20/0203/FUL | Demolition of existing Aldi store and 452 Pinhoe Road, construction of new Aldi foodstore, reconfiguration of car park, amended landscaping and amended pedestrian and cyclist access. | Aldi Foodstore Ltd And 452 Pinhoe Road Exhibition Way Exeter Devon EX4 8JD

18th March 2020

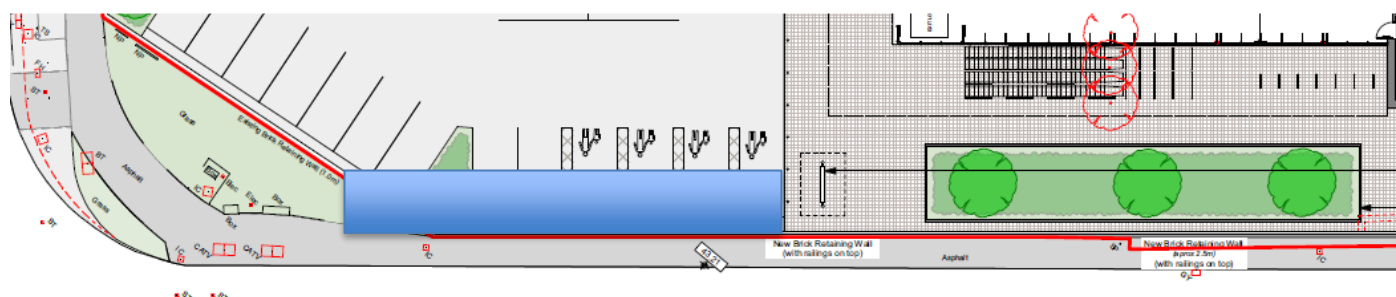
There is no mention of cycle access on the submitted plans, but I assume it is intended to be along the proposed pedestrian access off Exhibition Road. This access is potentially dangerous as it includes a diagonal zebra crossing across the car park. Firstly a diagonal crossing is non-standard and secondly there will be cars reversing over the crossing when they enter and exit the adjacent car park spaces. This will clearly be dangerous for pedestrians and cyclists.

I suggest a far safer and attractive entrance for cyclists and pedestrians could be formed by a ramped access along the Pinhoe Road boundary as shown below in blue:
